TO : Chief Engineer
Through: Chief, Dams Branch
 Chief Designing Engineer
FROM : Head, Concrete Dams Section

Denver, Colorado
DATE: August 3, 1964

SUBJECT: Failure of Two Medicine Dam

Photograph No. 1
Two Medicine Dam - View from left abutment. 6-11-64

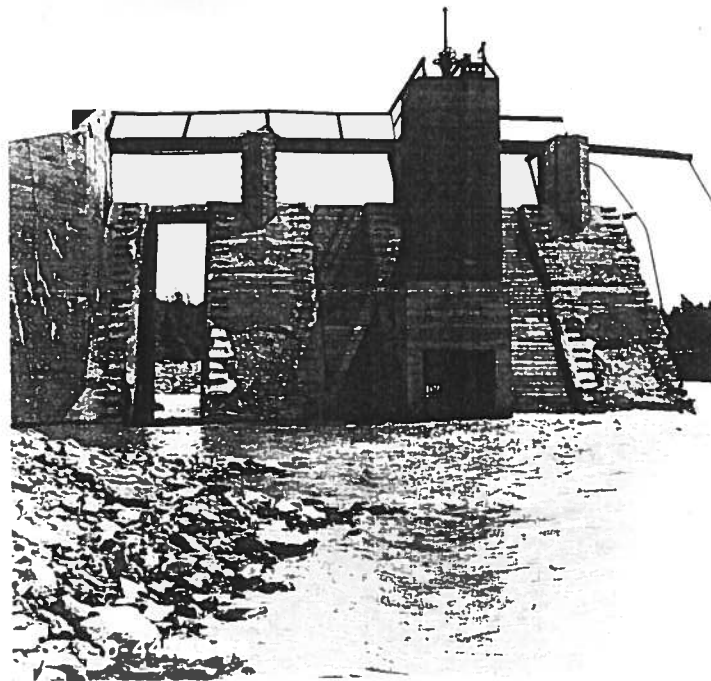
As a result of heavy rains in the area around June 7 and 8 of this year, which created above normal discharge, the dam failed, see Photographs No. 1, 2, 3, and 4. The failure occurred by overtopping of the embankments at about 3:30 p.m. on June 8. On June 11, accompanied by Mr. G. R. Hanson, Chief, Field Engineering Branch, Projects Office, Great Falls, I visited the site of the dam and examined the portions of the structure still standing. The request to make this inspection was made by the Regional Director, Region 6. Before going to the site, we stopped at the Office of the Project Engineer, Bureau of Indian Affairs, Blackfeet Indian Reservation, Browning, Montana, where we reviewed drawings, examined recent pictures and discussed the failure of the dam. The Bureau of Indian Affairs calculated that the peak discharge during the flood was 9,600 cfs and the Geological Survey in their letter of July 15, 1964 stated the maximum water surface elevation to be 4883.3. Since all the stop logs were in place and since the calculated capacity of the spillway and outlet was much less than the estimated discharge, the dam failed because of inadequate spillway capacity being available.

Photograph No. 4
Two Medicine Dam - View of right embankment showing remains of
spillway retaining wall. 6-11-64

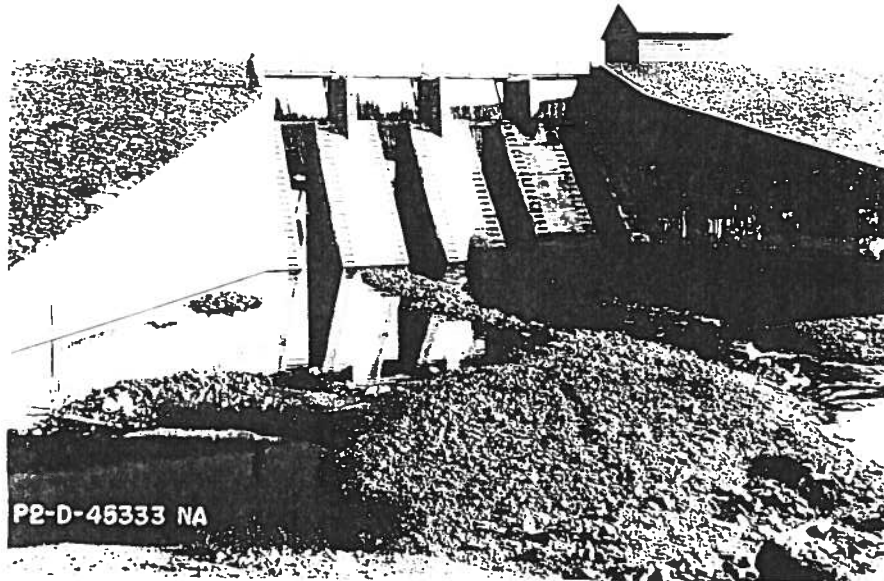
side of the spillway has been washed away except for a part of the upstream section. As the flood flow cut through the embankment, it evidently undermined the footing of the counterforted retaining wall and the wall toppled into the newly created river channel, see Photograph No. 4. Similar action took place on the left side of the spillway, but the flood receded before this wall completely failed. This wall had tilted sufficiently towards the abutment to allow the stop logs in the first spillway opening to be unseated and washed away, see Photographs No. 2 and 3. It is not known how much of the timber cribbing which served as a spillway apron has been washed away. The row of timber sheet piling at the heel of the spillway structure and at the end of the apron can still be seen in place.

Photograph No. 5
Two Medicine Dam - View of dam taken upon
completion of construction, 6-1913

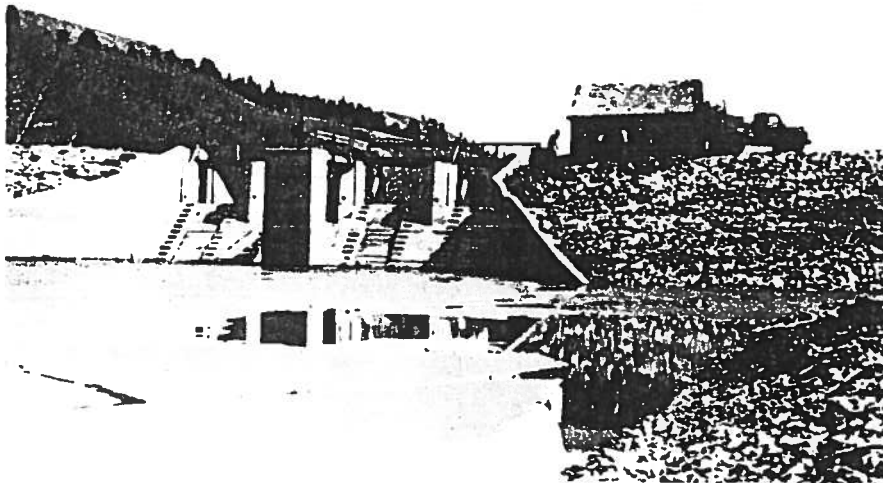
The failure of the dam, in all likelihood, started at the contact between the earth embankments and the retaining walls as the freeboard on the embankment decreased with the rising reservoir. In these areas there was a definite indication of settlement in the embankments. Photograph No. 5, taken in 1913, and Photograph No. 6, taken at a more recent date, show perhaps as much as 3 feet of settlement at the counterforted retaining walls. This area would form the shortest and easiest path for discharge over the embankments. Insufficient compaction of material in this area or shrinkage of the material from the wall due to drying would increase this weakness. Once the water could find a path through the embankment, the dam was doomed.
